Application No. 09/739,979
Amendment dated: Dec. 7, 2004
Reply to Office Action of: June 7, 2004

Amendments to the Drawings:

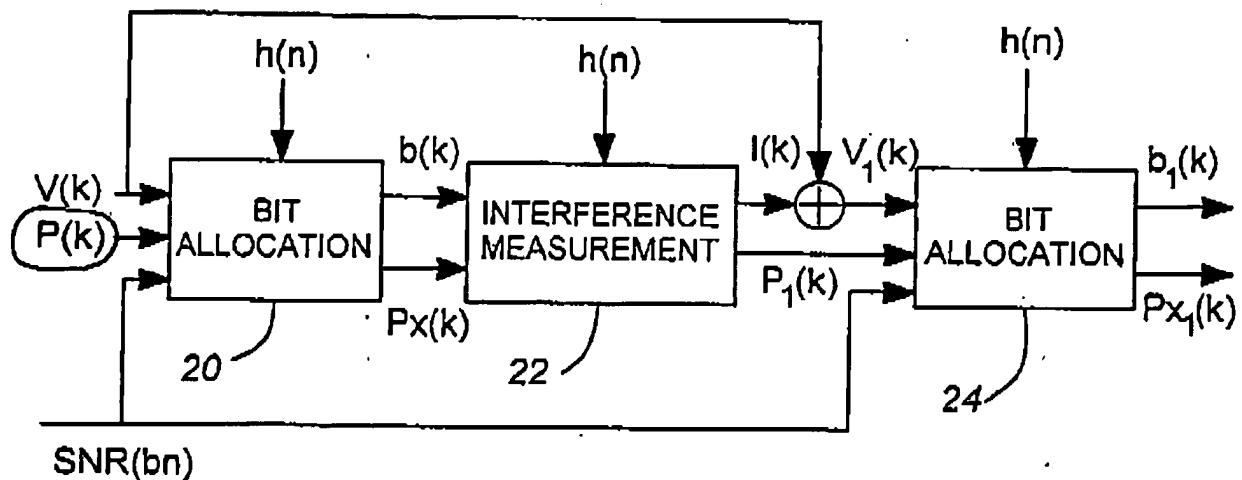
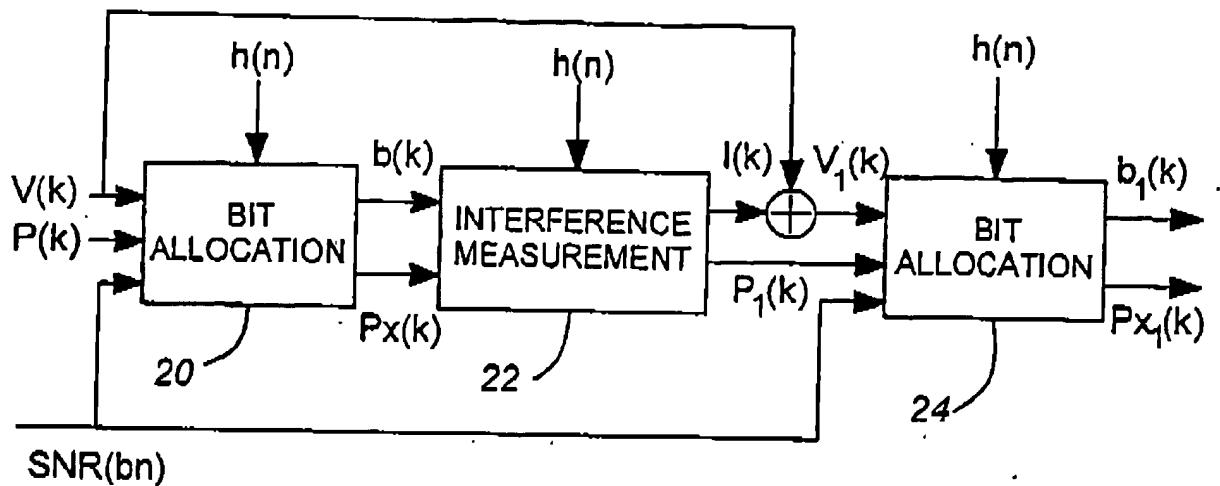
In amended Figure 4, the reference P(k) has been associated with the middle input of box 20, since the third (lowermost) input receives the signal-to-noise ratio SNR(bn).

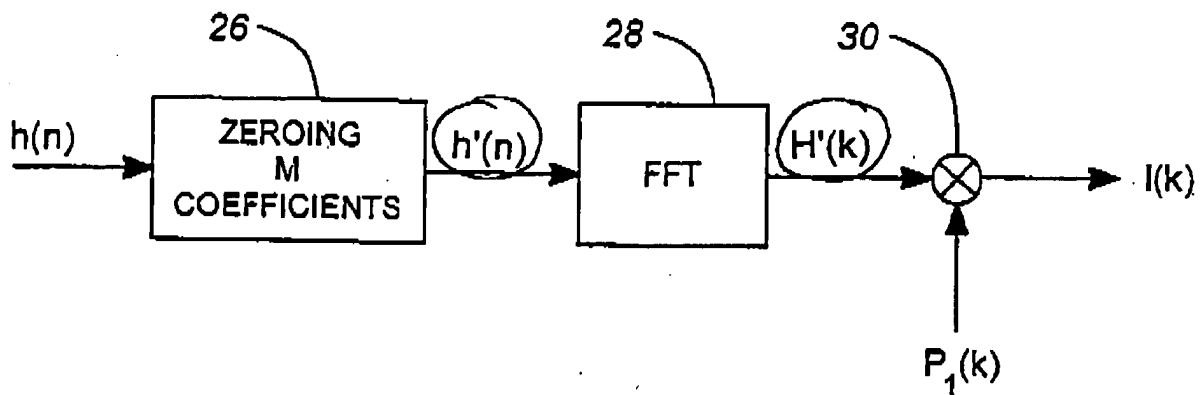
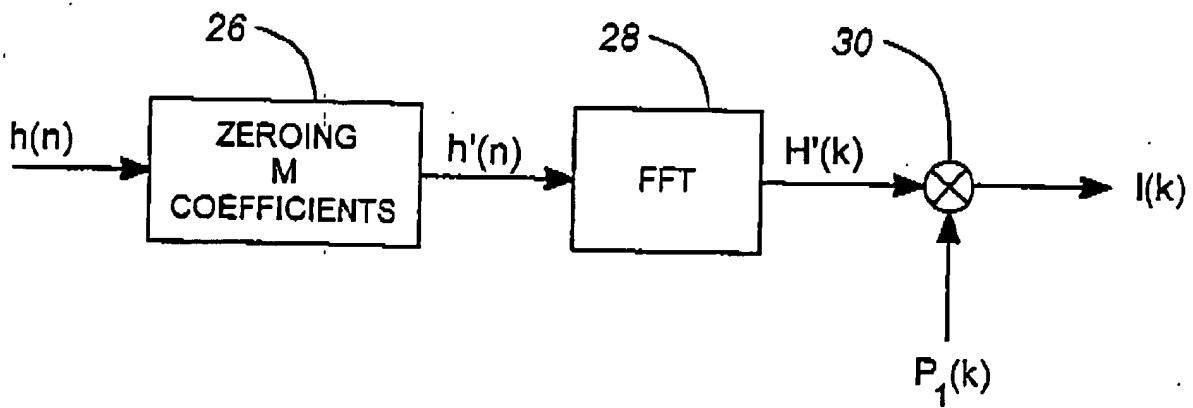
In amended Figure 5, the output of box 26, which is the residual impulse response, has been labelled h'(n) and the output of box 28, which is the residual impulse spectrum, has been labelled (H'(k)).
